Re: HS book

I think the Introduction is close to be sent as a teaser to Wiley

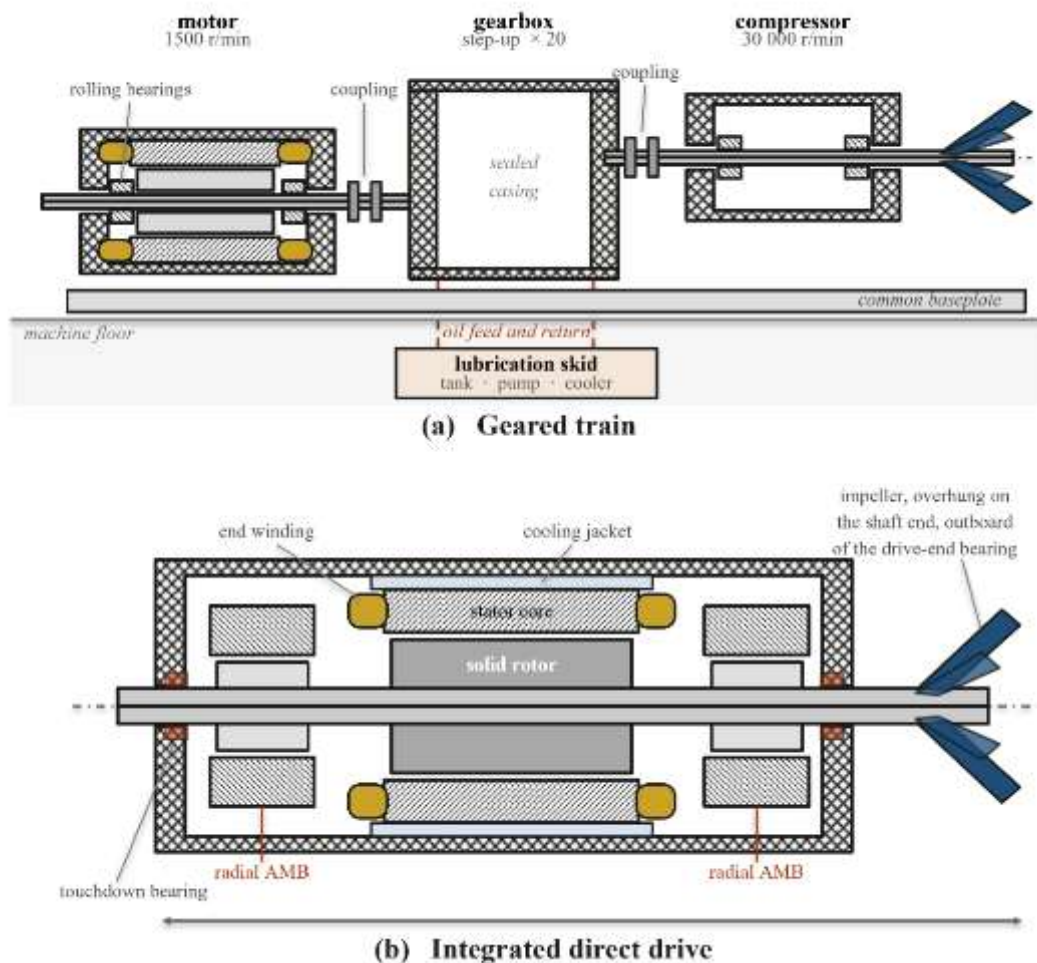
Good question. Now you are on a very schematic end of possibilities. On the document I still see this. Might it be possible to try to use AI further to try to get a photorealistic picture of the left-handed system but leave the cogwheels out? Oil cooler is missing. The right hand version is not according to HS technology at all but should be more like your new right-hand version.

Then the AI generator Fig. of the geared system is naive. I recommend removing the gears and showing just a box. Or at least the gears should be in the right direction not seen from the front as in the Fig now.

P.S. I already updated the geared system figure as given below. Is it still looks too naive?
